RFI

RFI #: 137
Date: 6/1/2012
Job: EB-02 Keller Springs Lofts
Phone: 877-777-5115

Subject: Trench Drain in Garage

RFI 137

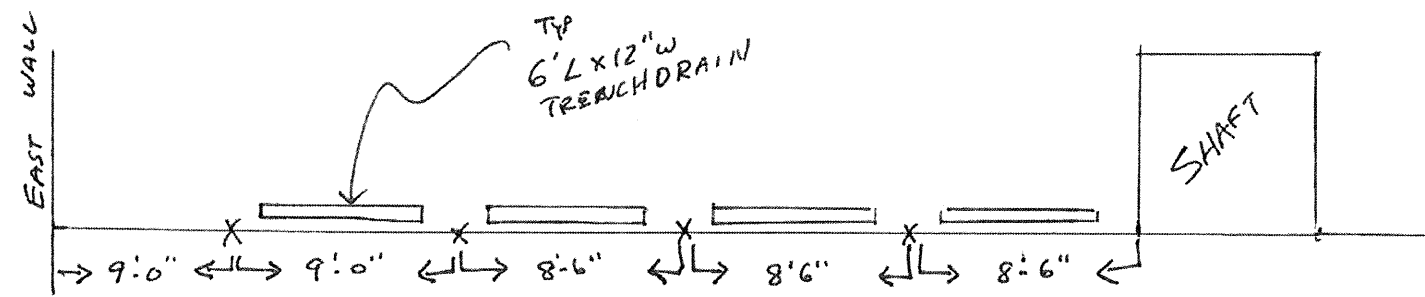
Request: The trench drain shown on P-3.6 scales to about 24 feet in length. The actual opening in the double tee is about 6'-3" x 10". Is the 6'-3" size enough to handle the water load coming down the ramp? What size drain (depth) would be needed to handle the water?
Date Required: 6/11/2012

See the attached sketch sent for the latest trench drain layout and pipe sizing.
